From: [Skyler Wildenstein](#)
To: [Chisler, Clinton, EMNRD](#)
Subject: [EXTERNAL] FW: Responses to agency comment letter dated 12/19/22 re Section 12 Reclamation
Date: Thursday, December 29, 2022 1:58:32 PM
Attachments: [SECTION 12 MINE SHAFT CLOSURE DESIGN draft for comment 122822.pdf](#)

From: Alan Kuhn <akkuhn41@gmail.com>
Sent: Wednesday, December 28, 2022 1:30 PM
To: Skyler Wildenstein <skyler@empiretrustinc.com>
Subject: Responses to agency comment letter dated 12/19/22 re Section 12 Reclamation

SECTION 12 MINE SHAFT CLOSURE DESIGN

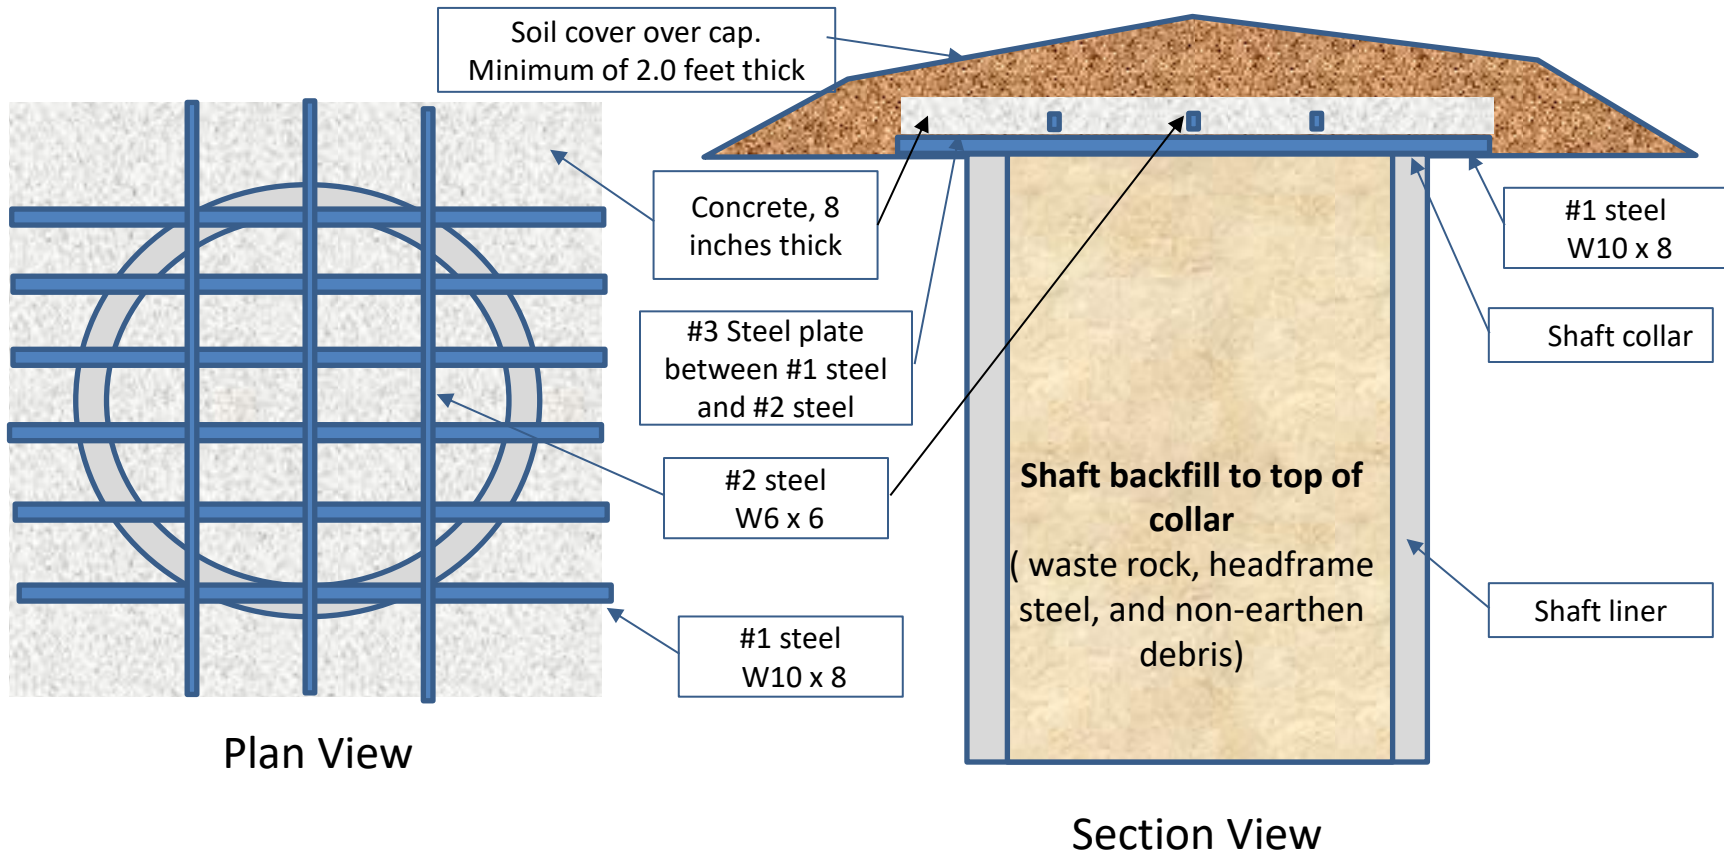
1. MMD requests that Southwest Resources Inc. submit shaft closure designs including but not limited to the following information.

a. Types of materials with associated quantities to be disposed of down the shaft. ***Mine debris to be placed in the shaft include the structural steel from the headframe; miscellaneous metal, glass, wood, and plastic trash scattered around the site. We estimate that approximately 2332 lineal feet of structural steel, various amounts of electrical and mechanical equipment, and assorted other solid debris totaling about 150 CY will be placed in the shaft, along about 4000 CY of waste rock.***

b. Shaft capping design including cover placed for positive drainage and vegetative cover. ***The shaft cap will consist of a rectangular grid of approximately 300 lineal feet of structural steel beams salvaged from the headframe supporting approximately 160 square feet of steel plate salvaged from the ore hopper, with a circular cast-in-place concrete top. A mound of loam soil will be placed over the concrete top.***

c. Headframe disposal details. ***Headframe steel will be scanned for radiological contamination. Contaminated steel will be placed in the shaft, and non-contaminated steel can be recycle for off-site use or placed in the shaft.***

LIST OF MATERIALS - SHAFT CAP				
Item #	Quantity	Material	Lengths, each, ft	Source
1	6	steel, W10 x 8	18	headframe demolition
2	3	steel, W6 x 6	18	headframe demolition
3	7	steel plate, 0.25-0.50 inch	8-10	ore chute and hopper demolition
4	6 CY	Concrete		C&E Concrete

- 1) Place remaining headframe demolition debris and other mine debris into shaft, alternating with waste rock and contaminated soil to minimize risk of leaving voids around debris.
- 2) Drop structural steel vertically into the shaft.
- 3) When the backfill surface is within 20 feet of the shaft collar, discontinue debris placement and fill the remaining space to the collar with waste rock and soil.
- 4) Allow the shaft backfill to settle for at least two weeks. Top off the backfill as needed to fill the shaft to top of collar.

- 1) Steel beams and steel plate salvaged from headframe demolition
- 2) Shaft collar surface repaired as necessary to support #1 steel beams
- 3) Six #1 beams placed in parallel, 2.8-3.0 feet apart
- 4) #3 steel plate place over #1 beams, tack-welded together
- 5) #2 steel beams placed orthogonally to #1 beams, on top of #3 plate, tack- welded to plate
- 6) Concrete formed over #3 plate and #2 beams, poured to 8 inches thickness
- 7) Place loam 1.5 to 2.0 feet thick over the structural cap at least 28 days after concrete is poured.
